SUBMITTAL SUMMARY REPORT 31420

PLAN NAME: SUNSET HILLS PHASE 4

Sunset Hills Ph 4 Improvement Plan
#31420

05.01

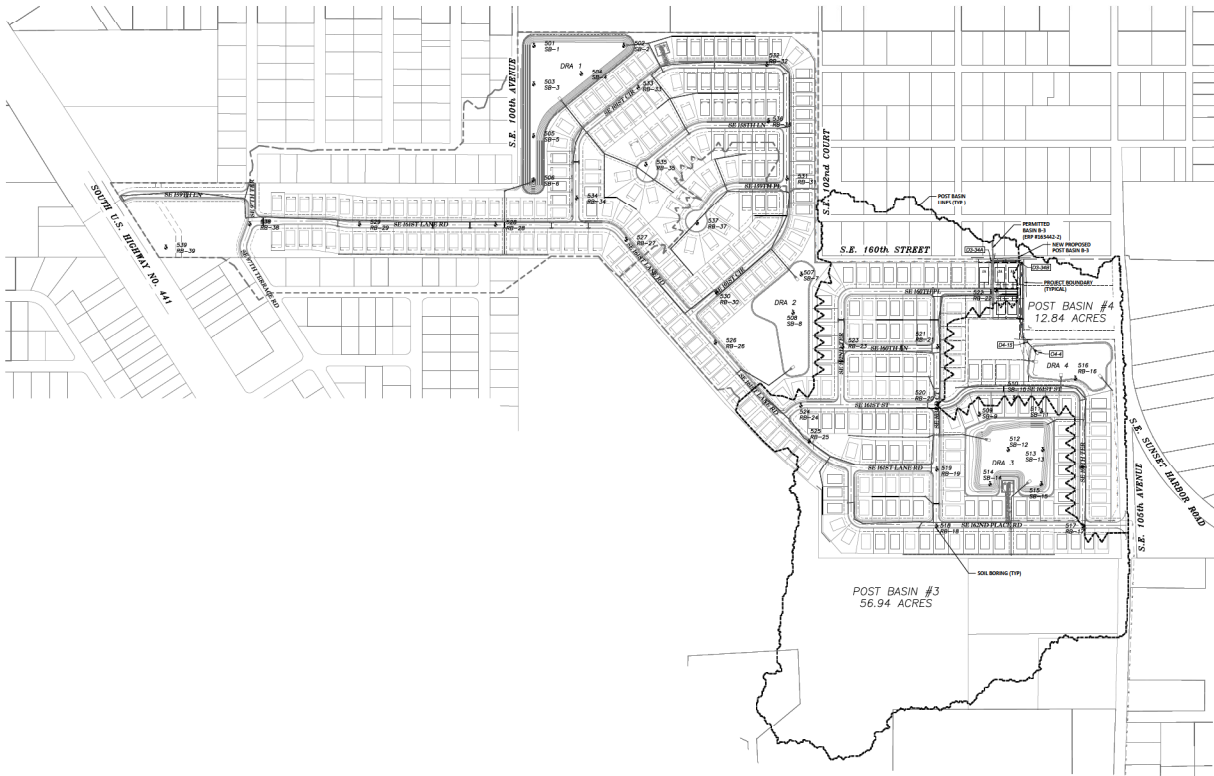
REVIEWER	MARKUP	DATE/TIME	FILE NAME	PG #
Susan Heyen	Provide Tree Preservation Plan, not included in this submittal	12/11/2025 3:48 PM	File Category Placeholder.pdf	5
Susan Heyen	1. Sheet 05.01 indicates a 15' Type C buffer to be installed 2. Buffer plantings to be on the public view side of the fence 3. Provide plant schedule, native calculations, and all Code Required landscape information 4. Provide signed and sealed Irrigation plan 5. Provide signed and sealed Landscape Plan (6.2.1)	12/11/2025 3:50 PM	File Category Placeholder.pdf	20

07.01

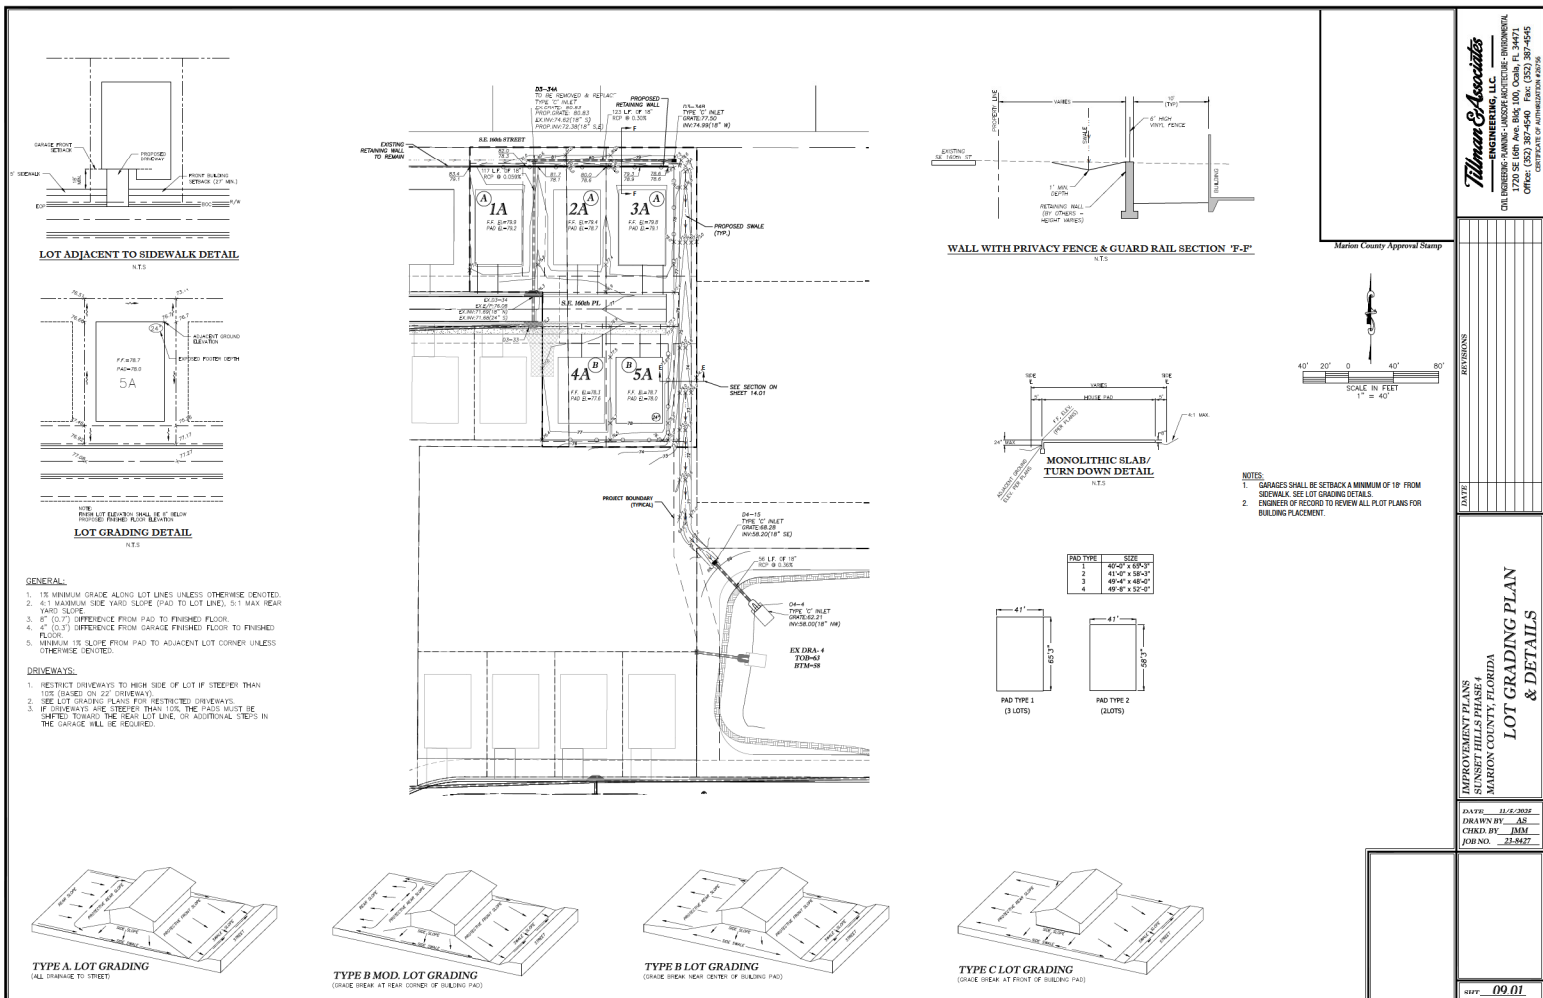
Corrections	Additional Utilities Comments (Not Resolved) - Corrective Action: 07.01 The 20-foot easement provided for the 8-inch sewer main is adequate; however, the main is not centered within the easement. As shown, Marion County Utilities would only be able to perform maintenance from the east side of the main. There is insufficient space to excavate around the west side of the main while remaining within the limits of the easement. Please revise the proposed main location to center it within the easement. - Additional Utilities Comments			
Corrections	6.14.5.A(2) - Proposed mains & connections shown (Not Resolved) - Corrective Action: 07.01 – The plans show a sewer service and water service serving Parcel 48206-000-00. The sewer service appears to tie into an existing service, and the water meter is shown within the property. The water meter must be relocated to the right-of-way. The sewer lateral for Parcel 48206-000-00 must connect directly to the sewer main running through the property. Marion County Utilities does not allow a sewer service and a sewer main to be located within the same easement.

N/A 6.14.9.A - Developer's Agreement
N/A 6.14.9.B - Transfer of Facilities to Marion County Utilities - PLAN NOTE:
YES 6.14.9.B - Bill of Sale Offsite mains will be conveyed to MCU through Bill of Sale; start this process with Carrie.Hyde@MarionFL.org sooner than later to avoid project closeout delays.
YES 6.15.1 - Potable Water Distribution System
N/A 6.15.2 - Decentralized Water System (WTP)
YES 6.15.3 - Fire Protection/Fire Flow Capacity defer to MCFR - served by MCU public water main
YES 6.15.4 - Water Main Piping Installation
YES 6.15.5 - Water Service and Connection
YES 6.15.6.A - Potable Water Metering - individual/banked, size
N/A 6.15.6.B - Irrigation Water Metering - size
N/A 6.15.6.C - Sewer service only (water meter required/shown)
YES 6.15.6.D - Meter Location
N/A 6.15.6.E - Meter Easements
NO 6.15.6.F - Meter Boxes 7/1/25 PG 7.01 - Move water service to lot line
N/A 6.15.6.G & H - Meter Sizing
